Assessment report to Sydney Central City Planning Panel

Panel reference: 2018SWC041

DA number	SPP-18-00005	Date of lodgement	7 March 2018
Applicant	Midson Group		
Owner	Anglican Church Property Trust Diocese of Sydney		
Proposed development	Demolition, removal of trees and site preparation works, and the staged construction of a 500 seat place of public worship (POPW), signage, 128 parking spaces and associated works in 3 stages		
Street address	49 Excelsior Avenue, Marsden Park		
Notification period	18 April to 3 May 2018	Number of submissions	1 (confidential)

Figure 1: Extract from Figure 17 'Bicycle and pedestrian network' of the Draft Marsden Park North Precinct Masterplan identifying that a dedicated shared pedestrian and bicycle pathway is to be provided in this precinct.

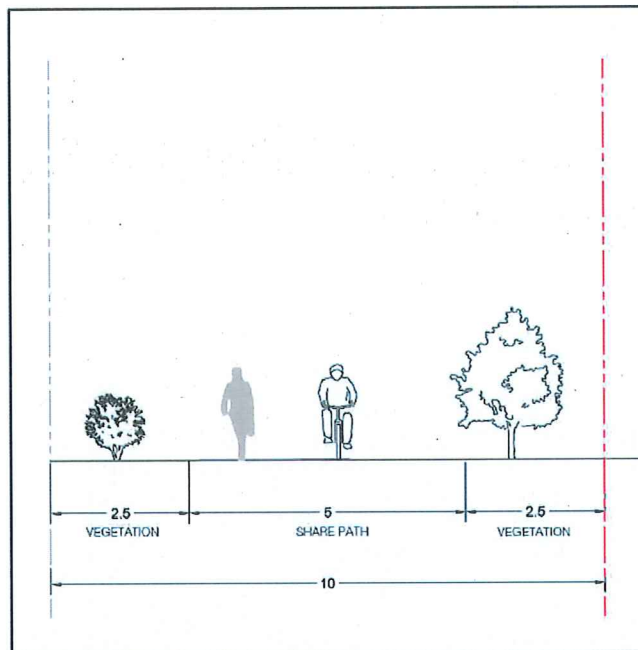
- 7.2.4 The draft Marsden Park North DCP also includes a requirement that Excelsior Avenue comprises a 'Main off road and shared pedestrian and bicycle pathway', with a width of 10 m as shown in Figures 1 and 2 below. This pathway is 3.5 m wider than the pathway width of 6.5 m for collector roads as shown in Figure 3.

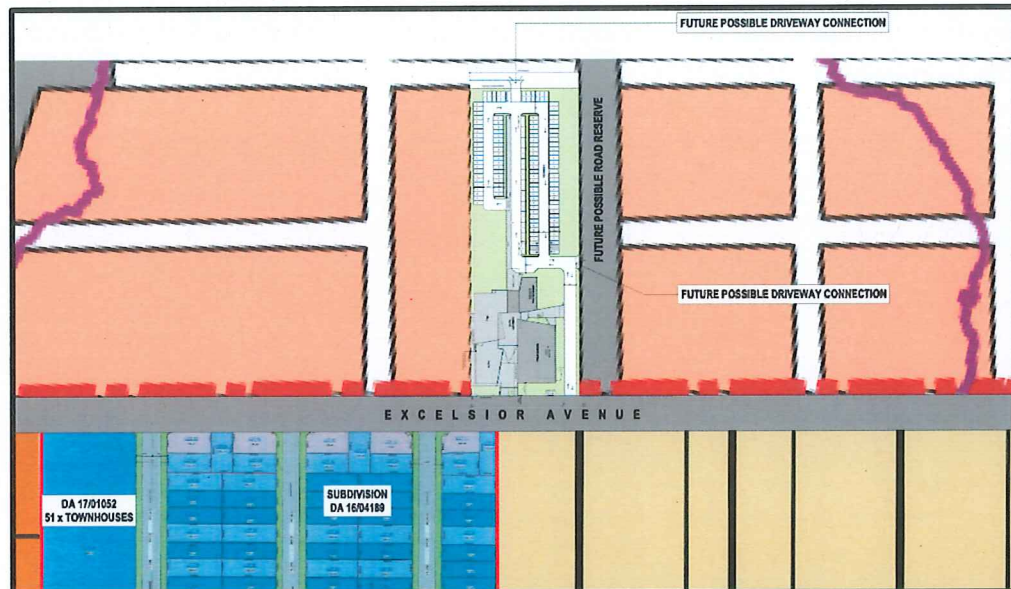
7.3.1 The applicant has demonstrated that the proposed driveway and carpark design provides flexibility to construct future driveway connections to the local road along the northern boundary of the site and the collector road to the east of the site, once constructed. Refer to attachment 5 for the applicant's full size development plans.

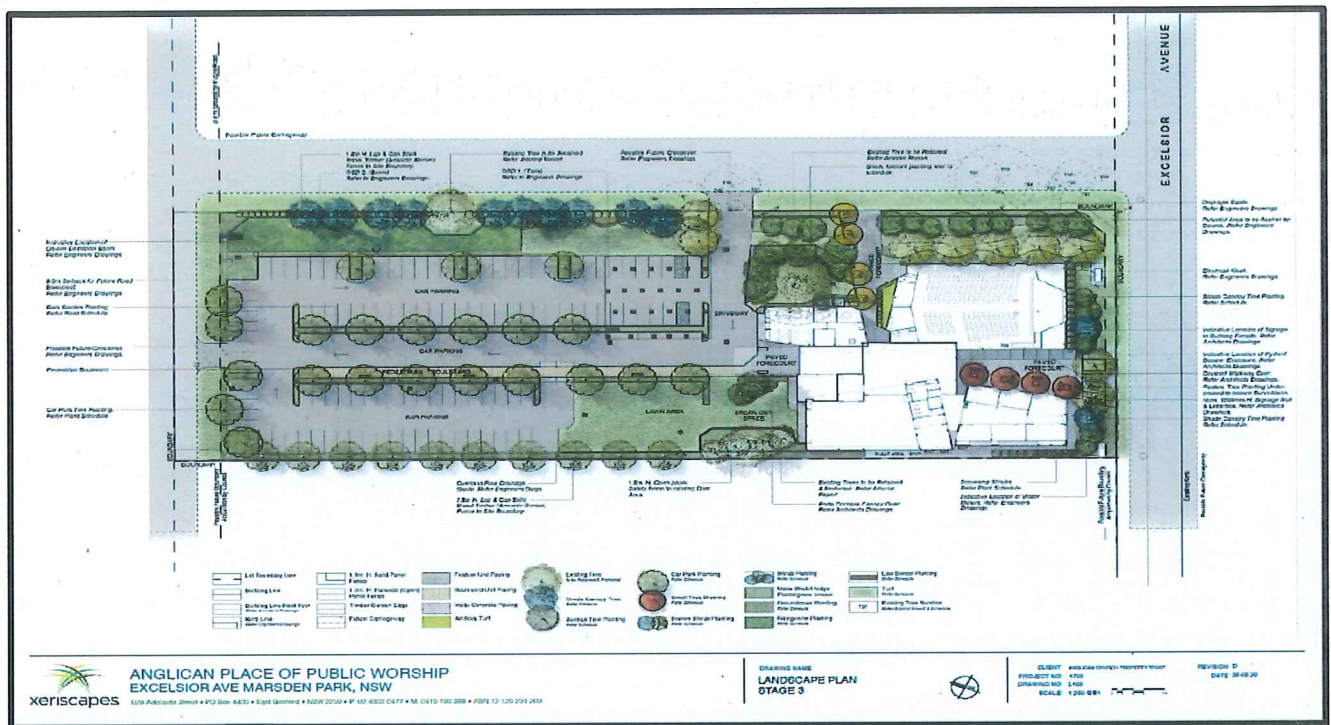
7.3.2 This scenario will facilitate the removal of the proposed driveway from Excelsior Avenue and its replacement with a landscaped garden area and splay corner at the intersection of the future roads at the SE and NE corners, as shown in the Figure 5 (Stage 3 Landscape Plan) below:
